December 6, 2016

Contract No. T201011301.01
Federal Aid Project No. NH-2015(25)
US 301, Summit Bridge Road and Armstrong Corner Road Intersection Improvements
New Castle County

Enclosed is Addendum No. 2 for the referenced contract consisting of the following:

US 301, SUMMIT BRIDGE ROAD AND ARMSTRONG CORNER
ROAD INTERSECTION IMPROVEMENTS

CONSTRUCTION PLAN	
SHEET NO.	51
TOTAL SHTS.	197

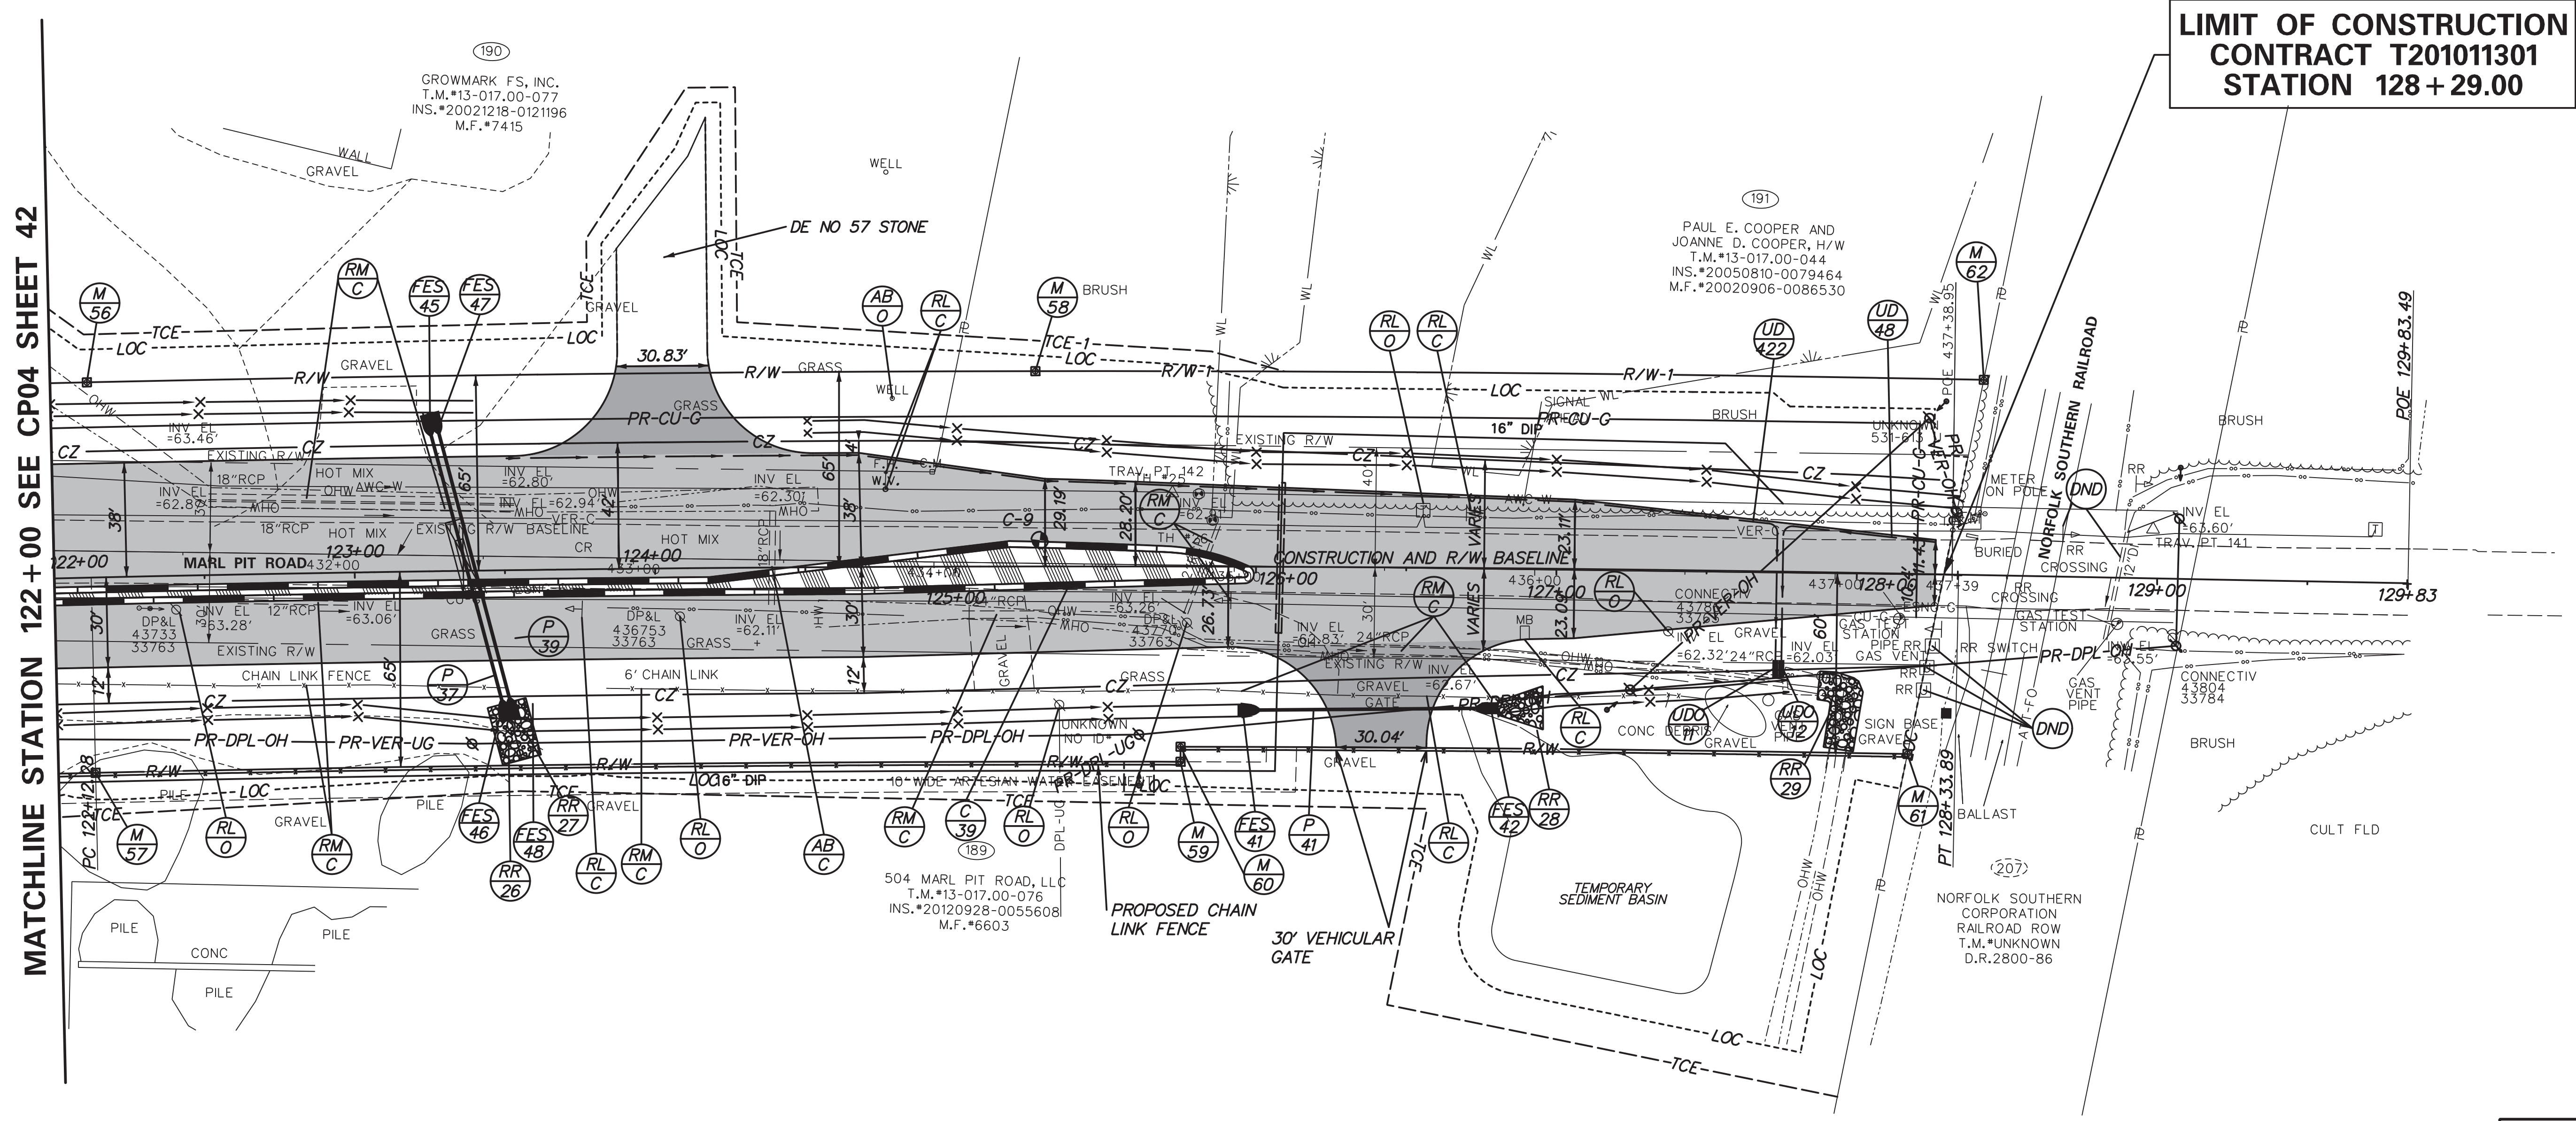
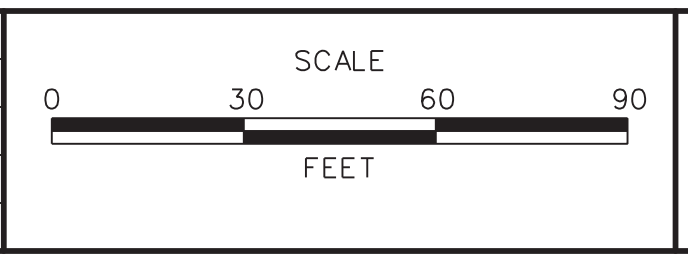
FLARED END SECTION SCHEDULE			
NO.	SIZE / TYPE	SLOPE	SAFETY GRATE
41	24" RCP	0.0020	NO
42	24" RCP	0.0020	NO
45	18" CORR. POLY.	0.0020	NO
46	18" CORR. POLY.	0.0020	NO
47	18" CORR. POLY.	0.0020	NO
48	18" CORR. POLY.	0.0020	NO

ADDENDUMS / REVISIONS	
▲ FES MATERIAL REVISED	DRB
